Access Compliance Report

Public Rights-of-Way

(Curb Ramps)

Intersection ID: 12983	Main Street: E_TRADE_ST	Cross Street: N_MYERS_ST	Location: S
ADA ID: D692B6CE8CC1	Ramp Type: Perp	Initial Pass/Fail: Pass	Overall Compliance: No
Severity Score: 0.25			
Codes/Mitigation Info/Possible Solution		Field Measurements/Component Compliance

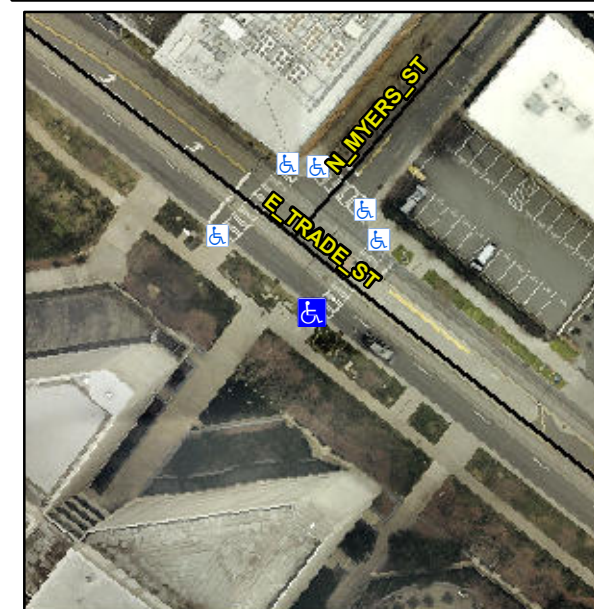
**Not Found, R304.5.3, R304.2.2-Perp,
R304.3.2-Para**

Compliance	Description	Data	Compliance	Description	Data
N/A	Ramp Length (in)	102.0	Yes	Ramp Slope (%)	5.5
Yes	Ramp Width (in)	70.0	No	Ramp XSlope (%)	4.5
Yes	Flare Type L	Curbed_NoWalkSurface	Yes	Flare Type RT	N/A
Yes	Flare Slope LT (%)	N/A	N/A	Flare Slope RT (%)	N/A
N/A	Flare Traversable LT?	No	N/A	Flare Traversable RT?	No
Yes	Landing Length (in)	72.0	Yes	DWS Provided?	Yes
Yes	Landing Width (in)	90.0	Yes	DWS Contrast?	Yes
No	Landing Slope (%)	3.8	Yes	DWS Length (in)	24.0
Yes	Landing X Slope (%)	3.9	Yes	DWS Full Width?	Yes
N/A	Landing Curb? (Y/N)	No	Yes	DWS Offset (in)	0.0
N/A	Shared Landing?	No			
Yes	Gutter Ponding?	No	Yes	Gutter Slope (%)	2.8
Yes	Gutter Lip Ht (in)	0.0	No	Gutter X Slope (%)	4.9
N/A	Painted X Walk1?	Yes	N/A	Painted X Walk2?	N/A
	X Walk 1 Direction	To NE		X Walk 2 Direction	N/A
N/A	X Walk 1 Width (in)	111.0	N/A	X Walk 2 Width (in)	N/A
	X Walk 1 Slope (%)	2.6		X Walk 2 Slope (%)	N/A
	X Walk 1 X Slope (%)	4.1		X Walk 2 X Slope (%)	N/A

**Remove & Replace Entire Ramp.
Remove & Replace Gutter.**
